Product Change Notification / KSRA-15BCAH919

CCB 4437 Final Notice: Implement MMT shipping tube for selected AT27xxxx, AT28xxxx and SST39xxxx products available in 32L PLCC package.

**KSRA-15BCAH919
CCB 4437**

❑ Tube Comparison (AT27xxxx and AT28xxxx Products):

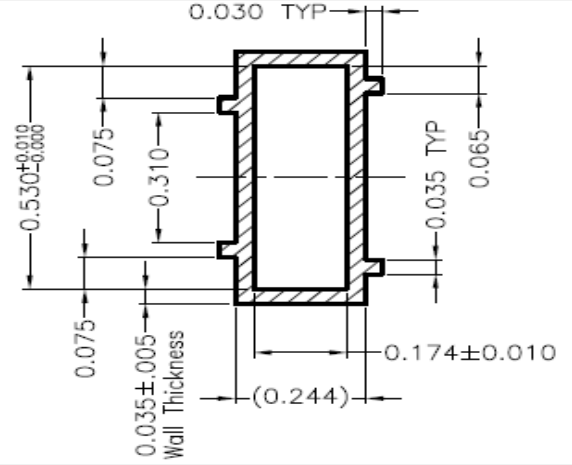
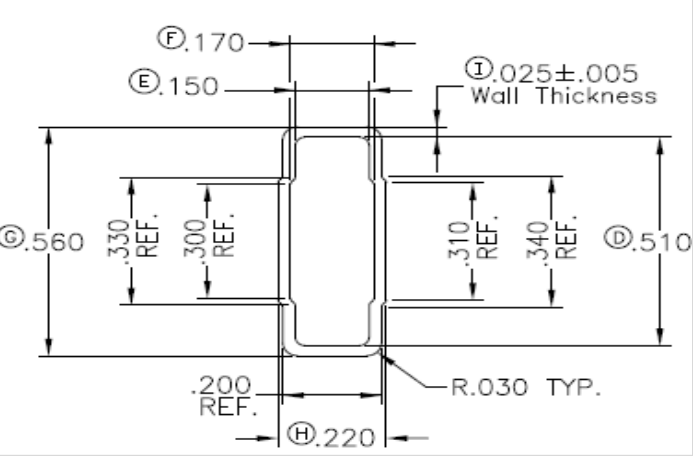
Pre change	Post change
Tube Dimension	
<p>Length: 20.40+/-0.10 inch Width: 0.600+0.015/-0.005 inch Tube Opening Length (A): 0.174 + 0.010 inch Tube Opening Width (B): 0.530+0.010/-0.000 inch Wall thickness (T): 0.035 + 0.005</p> <p>Tube Opening:</p> 	<p>Length: 21.70 ± 0.045 inch Width: 0.560 ± 0.015 inch Tube Opening Length (A): 0.170 ± 0.010 inch Tube Opening Width (B): 0.510 ± 0.010 inch Wall thickness (T): 0.025 ± 0.005 inch</p> <p>Tube Opening:</p>

❑ Tube Comparison (SST39xxxx products):

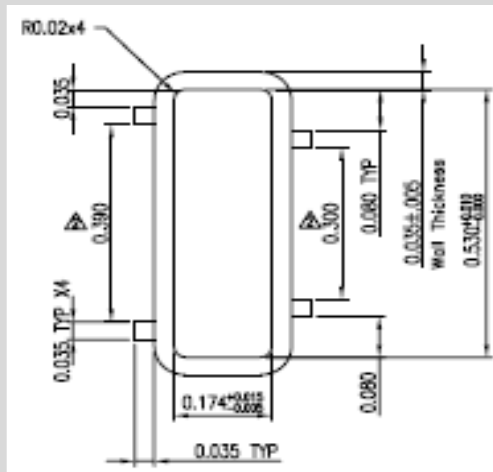
Length: 19.40+/-0.05 inch
Width: 0.600+0.015/-0.005 inch
Tube Opening Length (A): 0.174+0.010/-0.005 inch
Tube Opening Width (B): 0.530+0.010/-0.000 inch
Wall thickness (T): 0.035 ± 0.005

Length: 20.02 ± 0.05 inch
Width: 0.560 ± 0.015 inch
Tube Opening Length (A): 0.170 ± 0.010 inch
Tube Opening Width (B): 0.510 ± 0.010 inch
Wall thickness (T): 0.025 ± 0.005

For SST39xxxx products

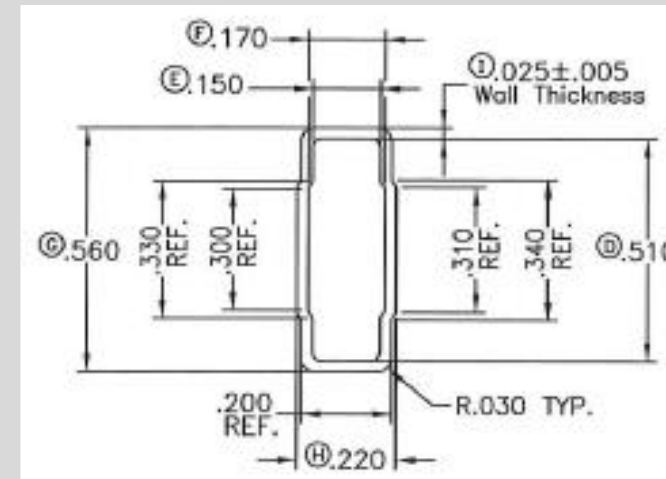
Tube Stopper

Blue and white colored stopper

Blue and gray colored stopper
